City of West Linn
PRE-APPLICATION CONFERENCE MEETING
Notes
September 15, 2011

SUBJECT: Installation of a four foot fence along retaining walls at Bolton Fire Station at 6050 Failing Street

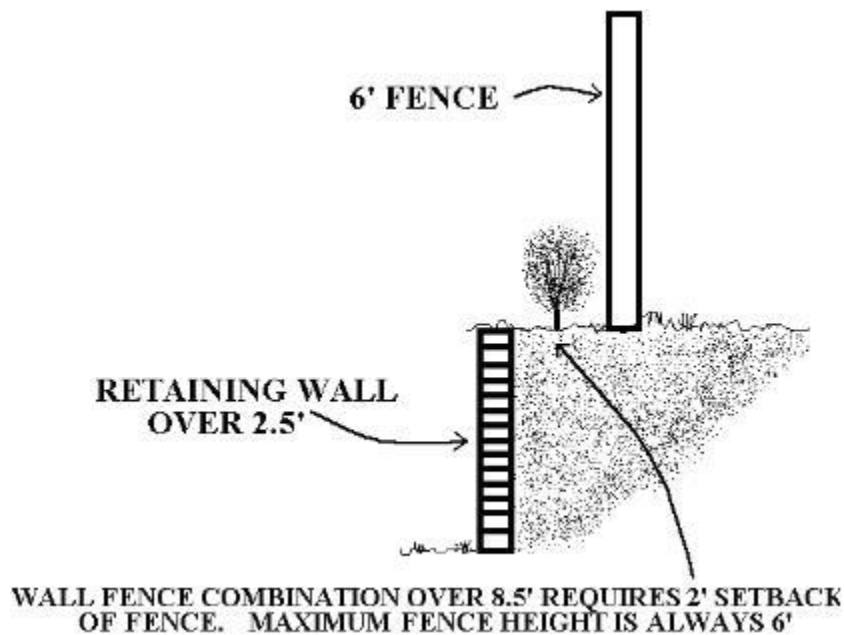
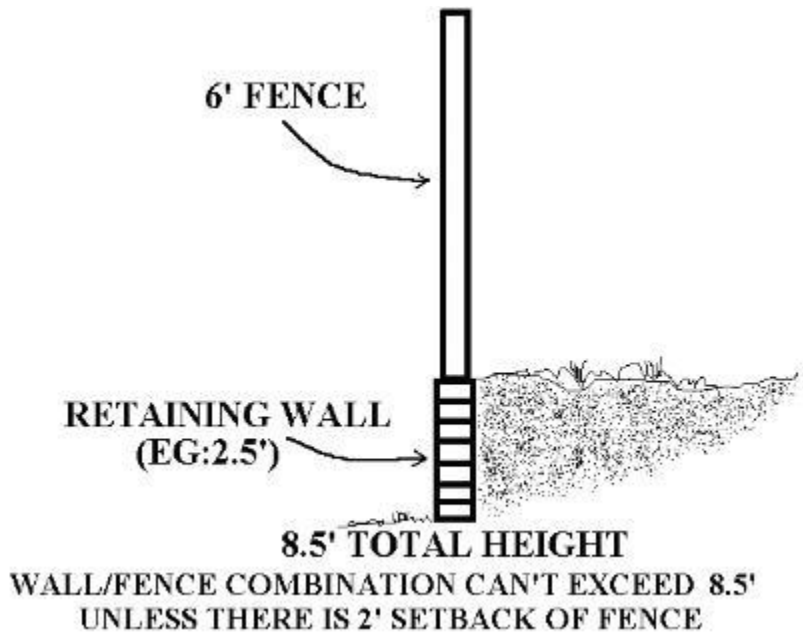
Another option which seems to address both the functional and aesthetic needs is a fence consisting of three or four galvanized wires or cables that run horizontally between steel posts 6-8 feet on center. Because the retaining wall is not a deck, stair rail or landing the building code standards do not apply.

TVFR considered this to be a reasonable option. The picture below has more horizontal cables and has a top railing but it gives an idea of what is being discussed.
